UNITED STATES PATENT AND TRADEMARK OFFICE

APPLICATION NO.	FILING DATE	FIRST NAMED INVENTOR	ATTORNEY DOCKET NO.	CONFIRMATION NO.
09/921,809	08/03/2001	Michael L. Perry	C-2462	8358

Office Action Summary

DETAILED ACTION

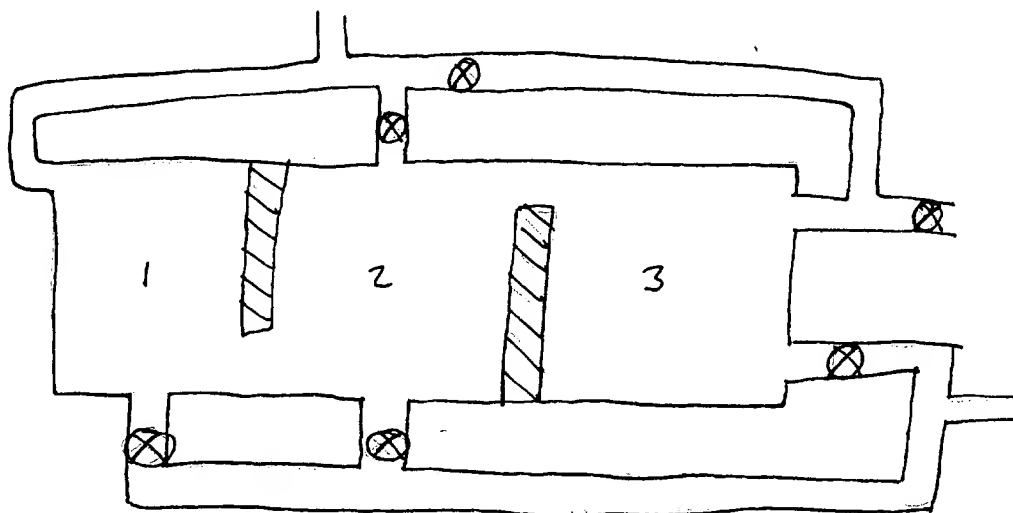
Regarding the Examiner's assertion that a skilled artisan could modify the valve structure of McElroy to accommodate three stacks, Applicants assert that "the Office is here challenged to show that it could be done: that is, if a third stack could also be brought into series or parallel with the other two, without altering how the stack 300 and the stack 200 receive and exit fuel depending on whether they are in series or parallel, then that should be shown, should be proven." The applicant's request for "evidence" of how the modifications can be achieved is noted and is addressed hereinbelow. However, the addendum to the request--that this must be shown without altering how the existing stacks of McElroy receive and exit fuel--is not believed to be justified or supported by the statute. Applicants state that "altering the configuration that is already there" is "impermissible in a prima facie obviousness rejection." However, by their very nature, obviousness rejections involve a modification of the prior art. Thus, Applicant's criteria that the existing configuration of McElroy cannot be modified is not seen as valid. As stated above, the principle of operation of McElroy is the switching between cascade and parallel flow. Adding a third stack to the configuration would not change the principle of operation of the reference. Furthermore, the addition of appropriate valves and conduits to accommodate the

third stack is a routine engineering problem that can be easily solved by a person of ordinary skill in the art. As an example, the following system was designed by the Examiner by adding onto the two-stack system of McElroy and adding valves and conduits (no valves or conduits were removed):

This drawing is merely an example of how such a system might look and is not intended to be limiting.
